# NORTHUMBERLAND DEVELOPMENT PROJECT **HOTEL**

**S73 APPLICATION**

THHTL-F3A-XX-XX-RP-A-0006

**DESIGN AND ACCESS STATEMENT ADDENDUM UPDATE**

**FIGURE 111.** Proposed Scheme Revision - Illustrative Composite Landscape Plan

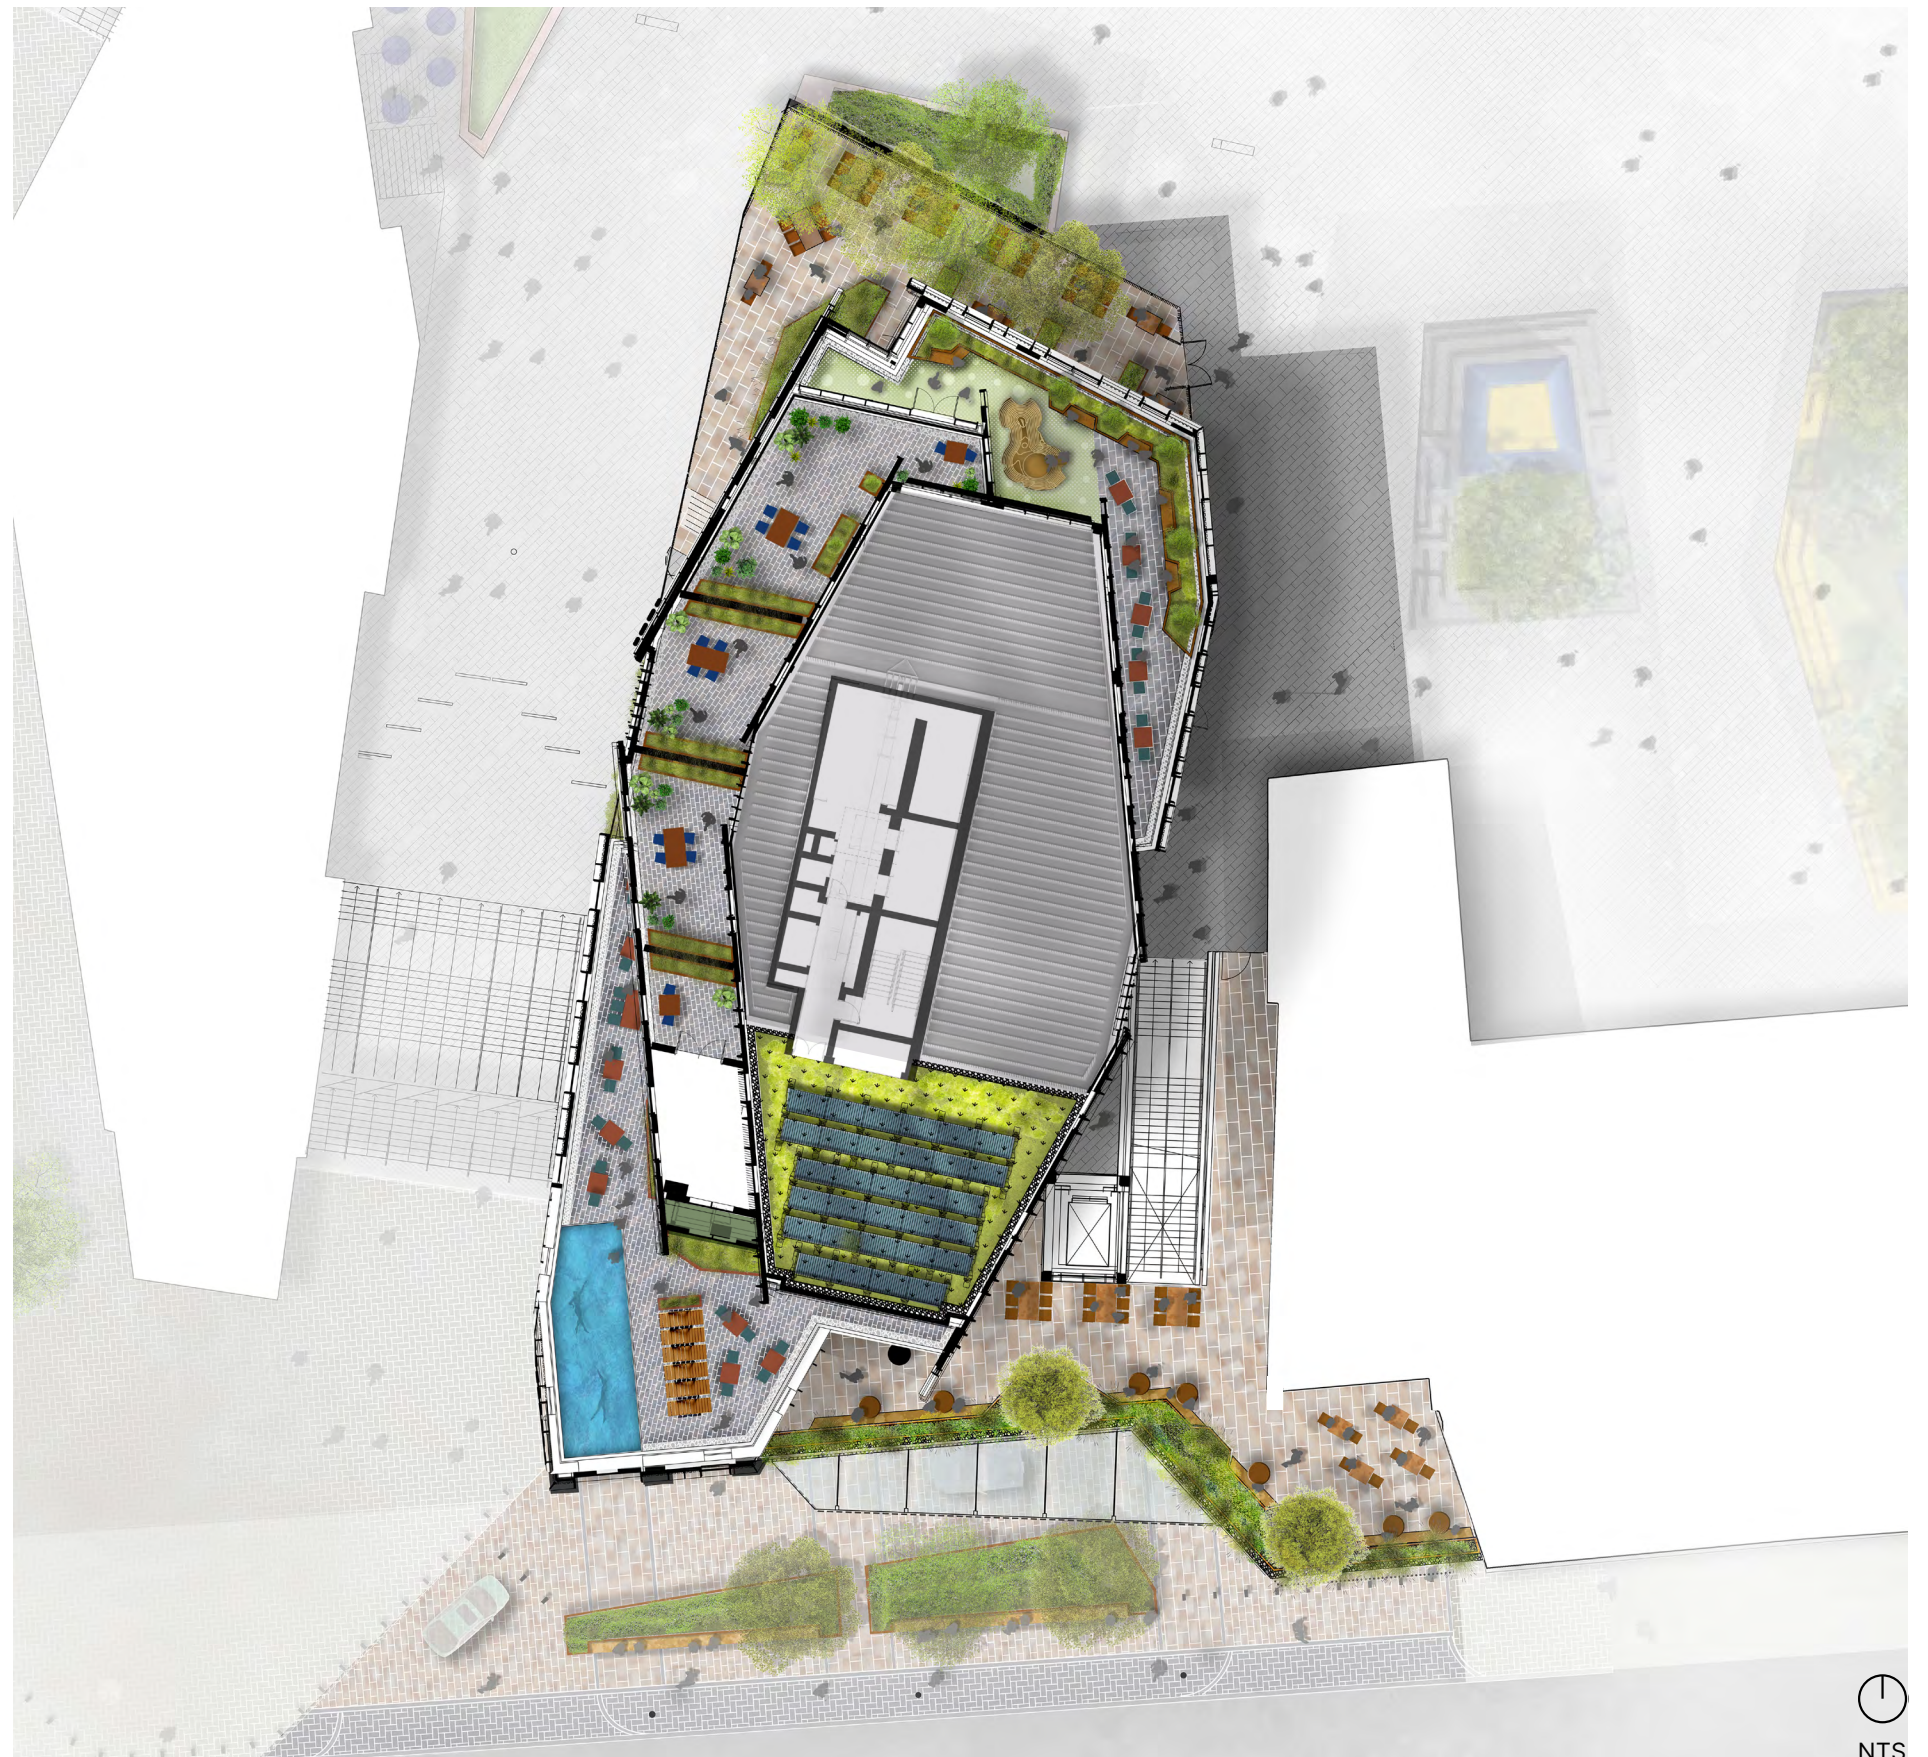
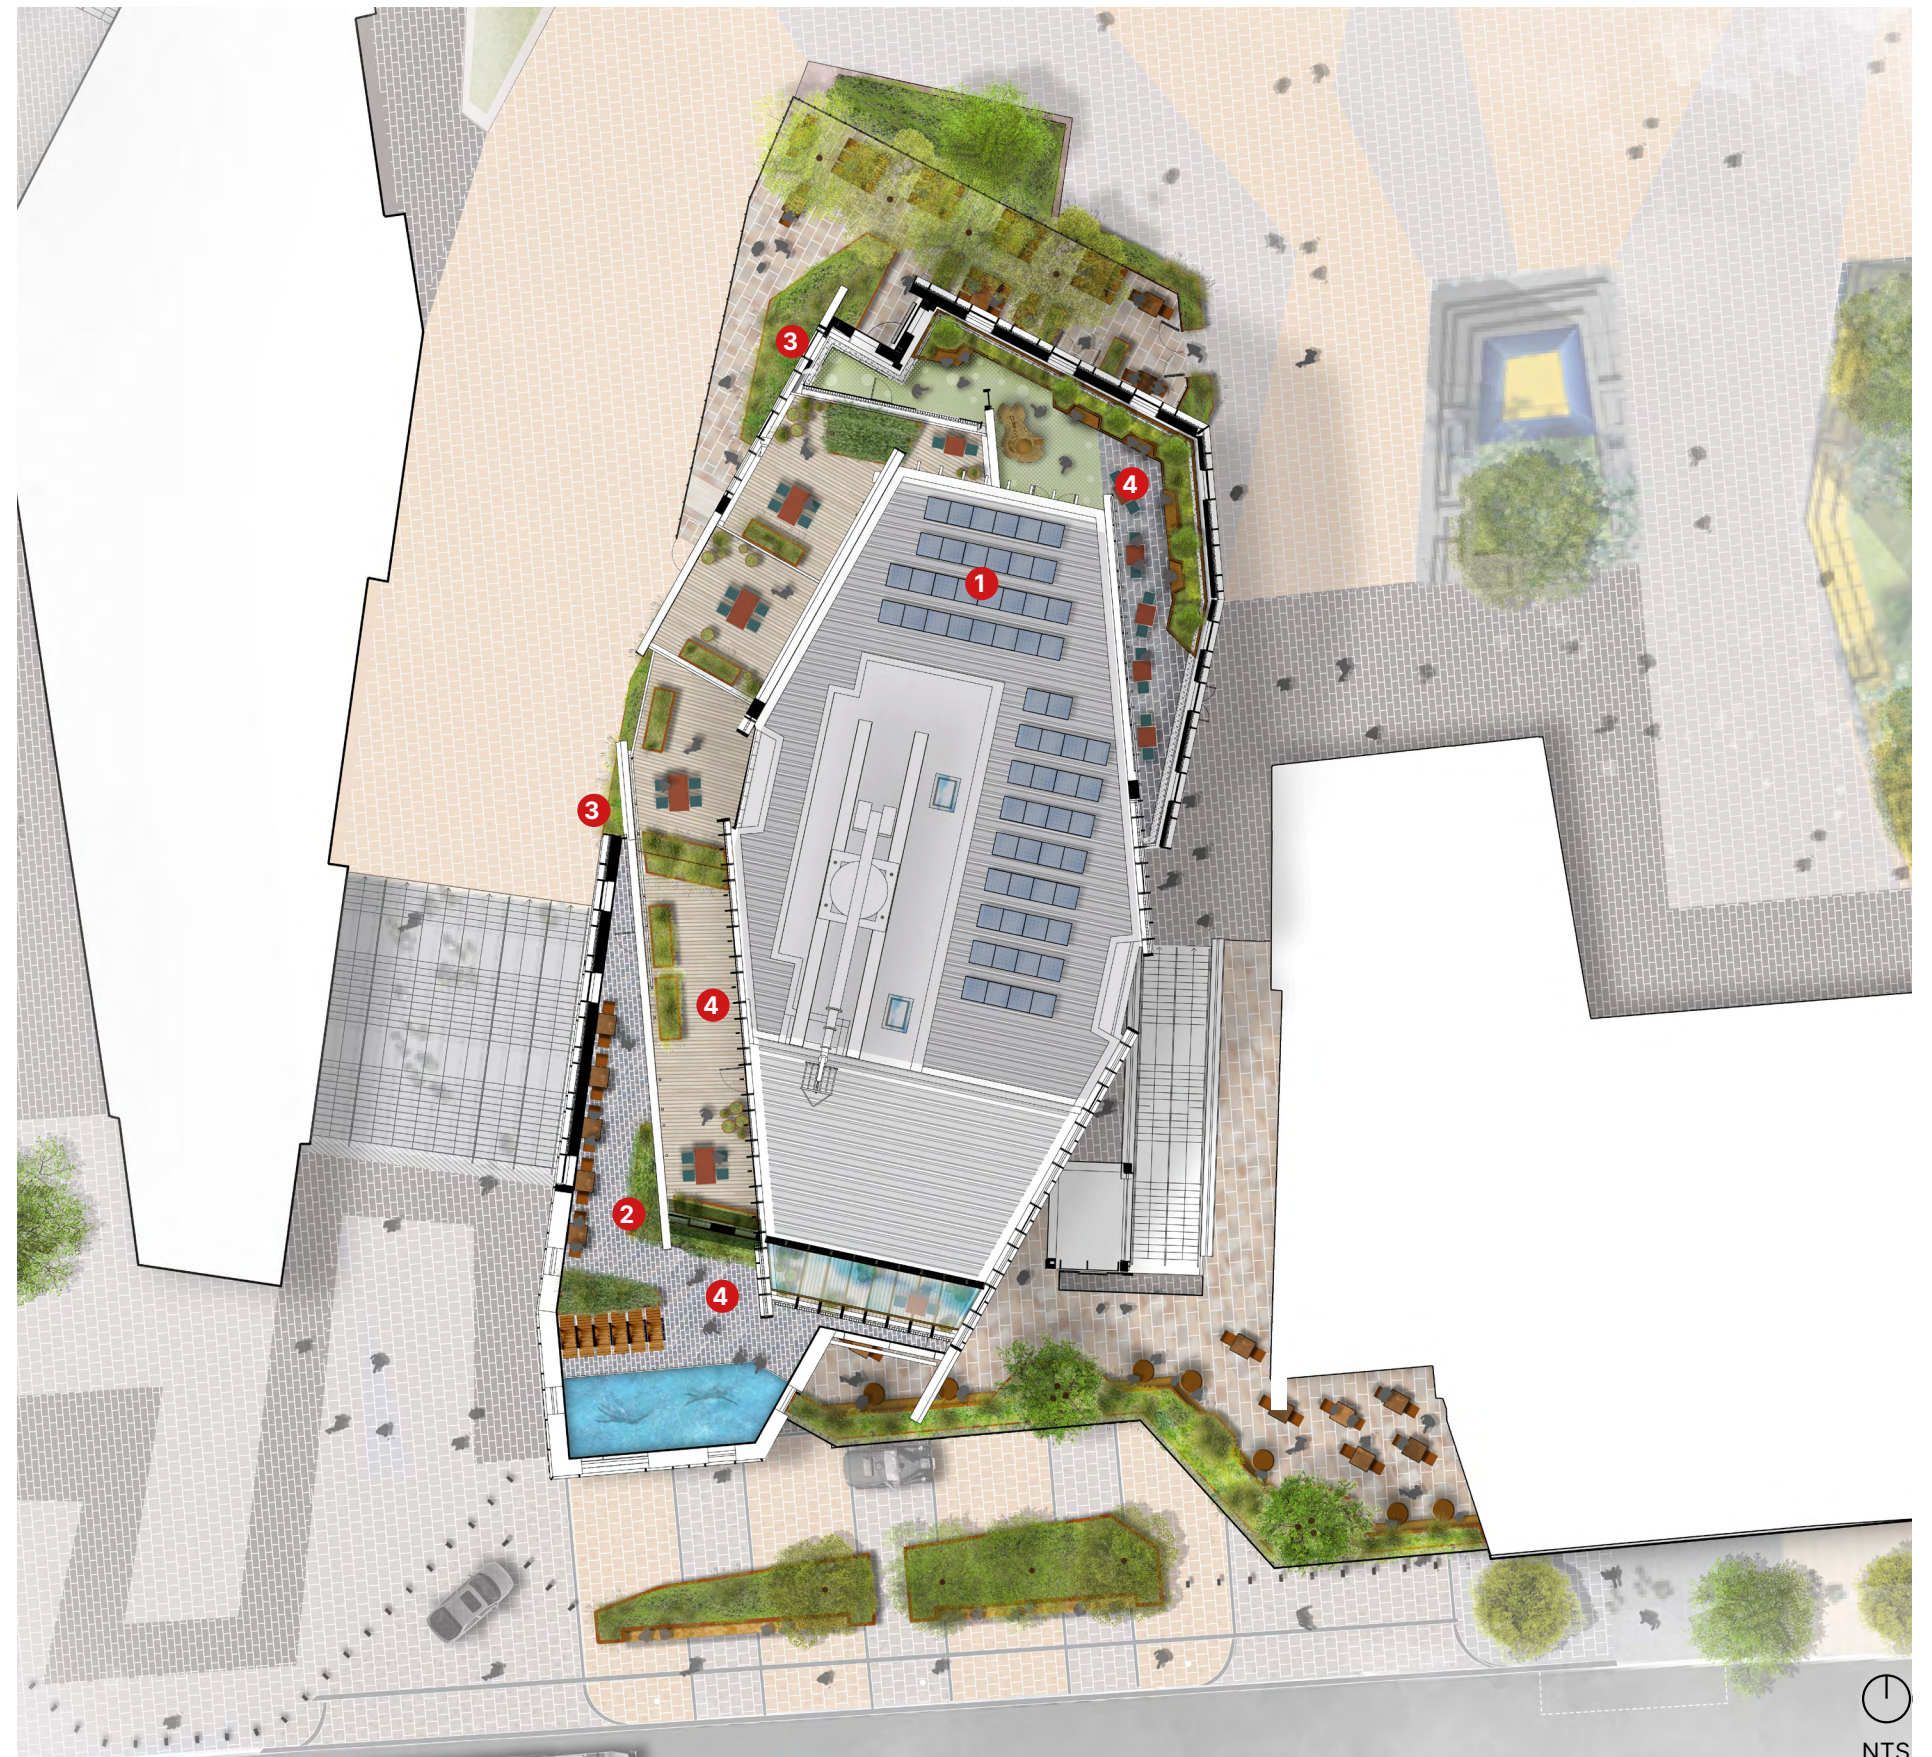
- 1 Roof plant extended with PV panels, biosolar roof removed.
- 2 Hotel amenity terrace additional planter added.
- 3 Podium level planted vertical wall added.
- 4 Permeable paving applied to terrace levels.

Updated Urban Greening Factor = **0.157**
